CITY OF IMPERIAL
IMPERIAL, CALIFORNIA

ADDENDUM NO. 2

TO THE PLANS AND SPECIFICATIONS FOR
LA BRUCHERIE LIFT STATION IMPROVEMENTS
BID NO. 2015-07

CITY OF IMPERIAL
 IMPERIAL COUNTY, CALIFORNIA
 LA BRUCHERIE LIFT STATION IMPROVEMENTS
 MECHANICAL SECTIONS & DETAILS
 DWG. NO. _____

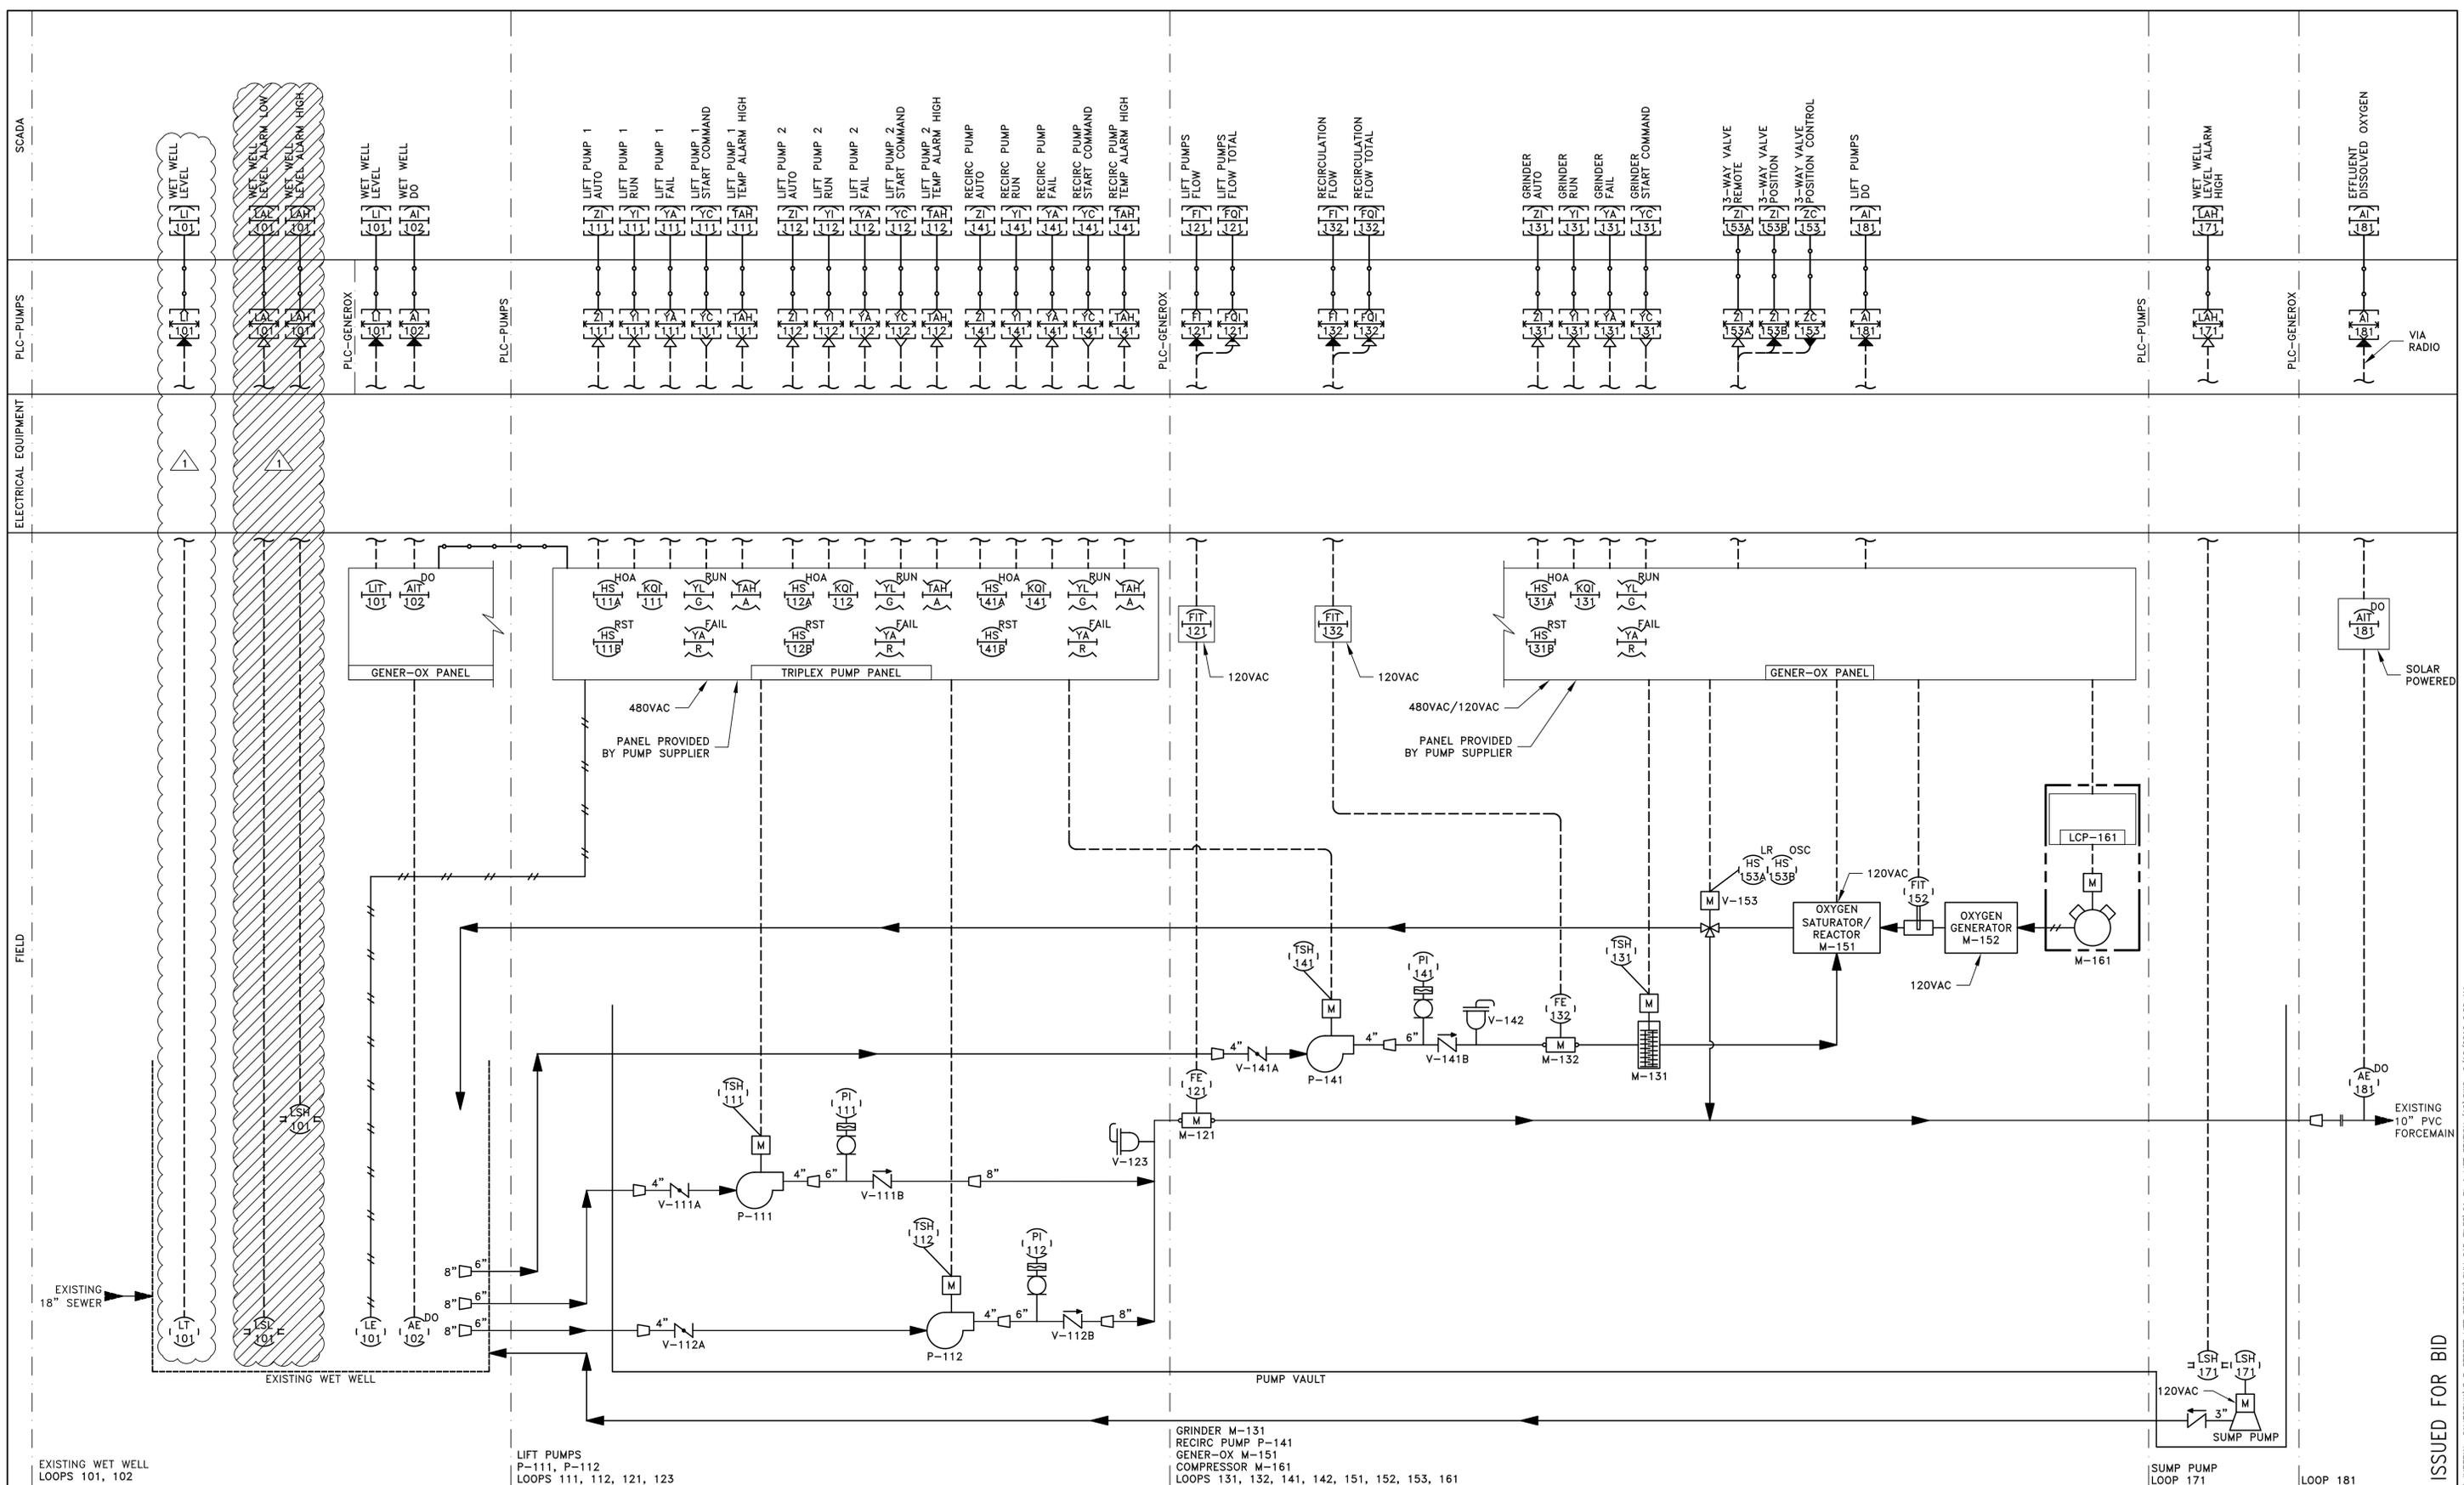
3. Sheet 8 (Attached and Sheet 7) – 4-inch Ductile Iron Pipe on left side of Mechanical Section B-B has been revised to be above grade. Ductile iron tee has been removed from right side of the same Section.

REVISIONS				
NO.	DATE	INITIAL	DESCRIPTION	APPROVED/DATE
Δ	5/15	SLB	CHANGED DISCHARGE PIPING TO ABOVE GROUND, REMOVED 6"x4"x6" TEE, & ADDED SUMP PUMP CALLOUT	5/4/2015
DESIGNED BY:	DRAWN BY:	CHECKED BY:

LA BRUCHERIE LIFT STATION IMPROVEMENTS
INSTRUMENTATION - P&ID
DUPLEX PUMPS

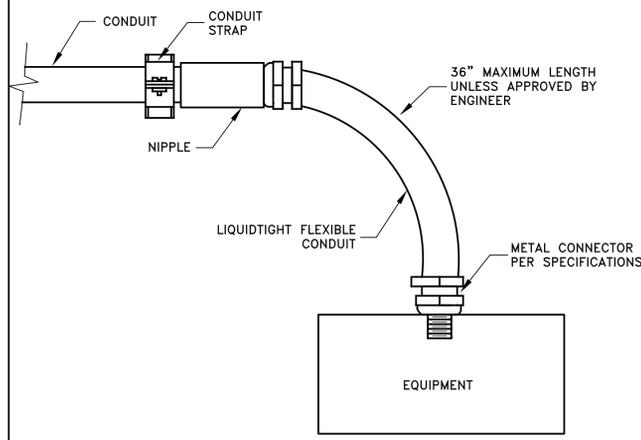
5. Sheet 14 – Detail A and B, "Steel Sheeting Partition Wall" has been removed.
6. Sheets 19 (Attached) – Wet Well Level and Alarms have been revised.
7. Sheet 22 (Attached) – Detail 509 has been replaced with Detail 522, a transducer will be utilized for level monitoring. Detail 510, 3/8" tubing shall be Schedule 80 PVC.

REVISIONS				
NO.	DATE	INITIAL	DESCRIPTION	APPROVED/DATE
1	05/15	DCL	LEVEL TRANSDUCER	MPJ 05/01/15
DESIGNED BY:			DRAWN BY:	CHECKED BY:

CITY OF IMPERIAL IMPERIAL COUNTY, CALIFORNIA	
LA BRUCHERIE LIFT STATION IMPROVEMENTS ELECTRICAL ONELINE & CALCULATIONS	
DWG. NO.	E-1

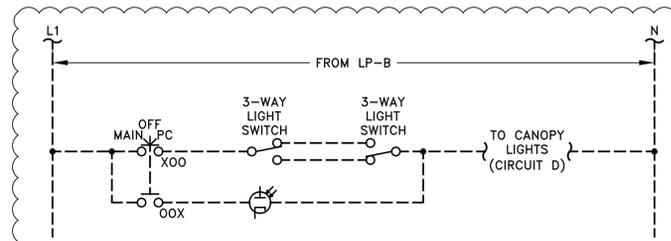
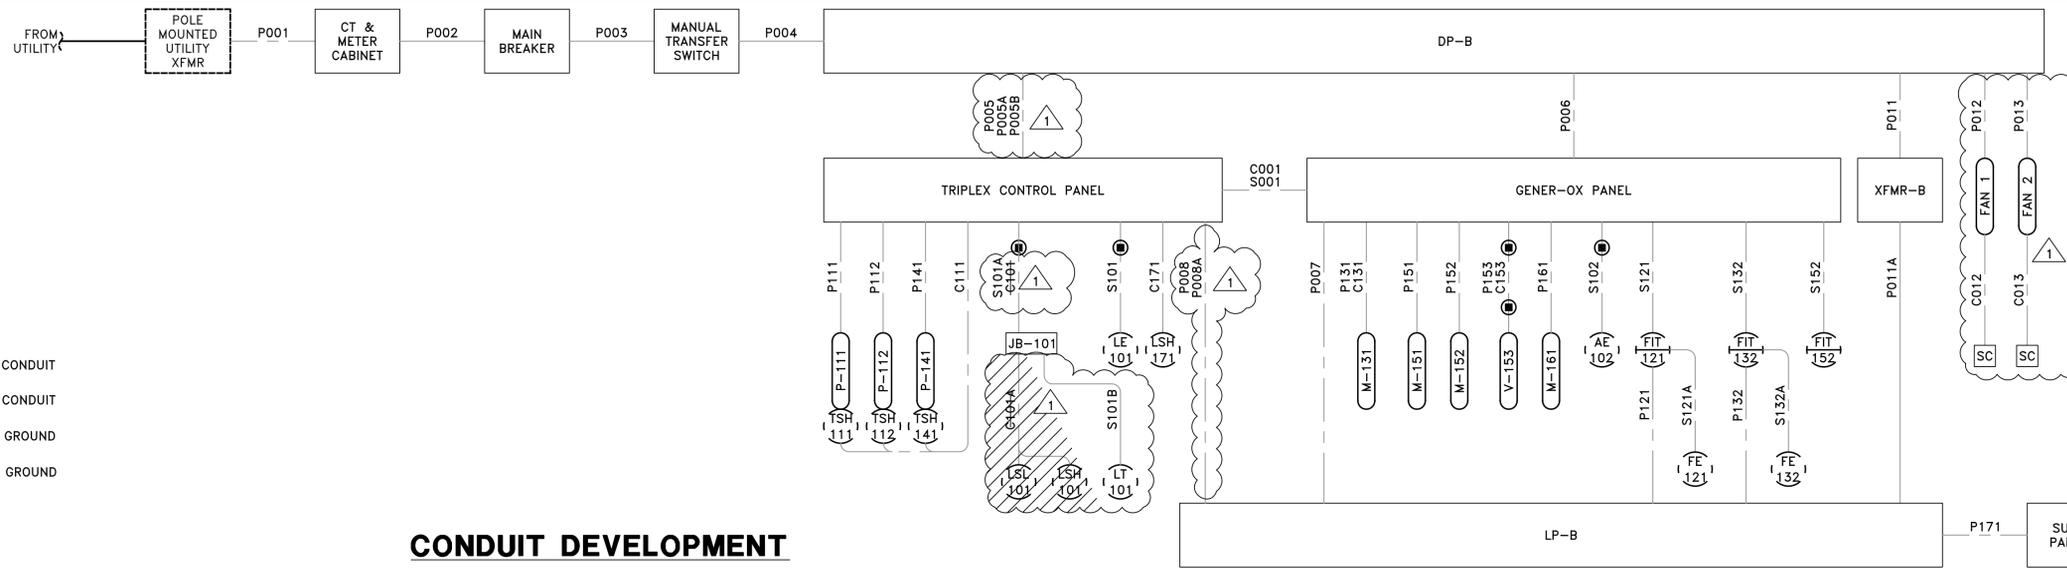
8. Sheet 23 (Attached) – Location of Electrical Panels has been revised. Note Addition of two (2) 10 ft. diameter, 480 Volt Powerfoil X2.0 ceiling mounted fans, by BigAss Fans. Fans and fan controls will be provided by the City and installed by the Contractor. City will also provide and install the CT/Meter Panel, Main Breaker Panel, Manual Transfer Switch, DP-B, Lighting XFMR, and LP-B. Also note that lighting and lighting circuits have been revised.
9. Sheets 24 and 25(Attached) – Oneline Diagram, DP-B and LP-B Calculations have been revised and a lighting bypass has been added. Conduit Schedule on Sheet 25 has been updated.

REVISIONS				
NO.	DATE	INITIAL	DESCRIPTION	APPROVED/DATE
1	05/15	DCL	SERVICE SIZE AND CALCULATIONS UPDATED	MPJ 05/01/15
